APRIL 29, 2025

WS1.5 TWIN BOM CHANGE AND IMPROVEMENTS

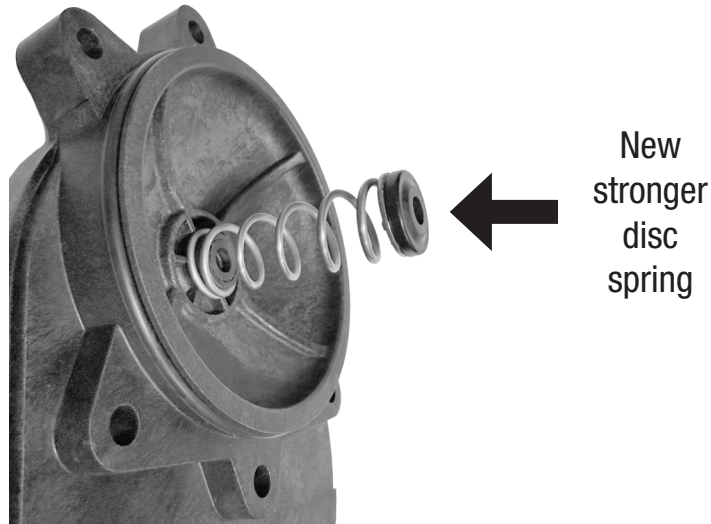
THREADED INTERCONNECT FITTINGS NO LONGER INCLUDED

We have removed the interconnect 1.5" to QC threaded fittings from all WS1.5 Twin Control Valves. This will allow each customer to decide which fitting kits are needed between the tanks and as always, the fitting kit for inlet/outlet of the Control Valve that was purchased separately.

See the table below for all WS1.5 Twin fitting kits available (3 sets of fittings per valve).
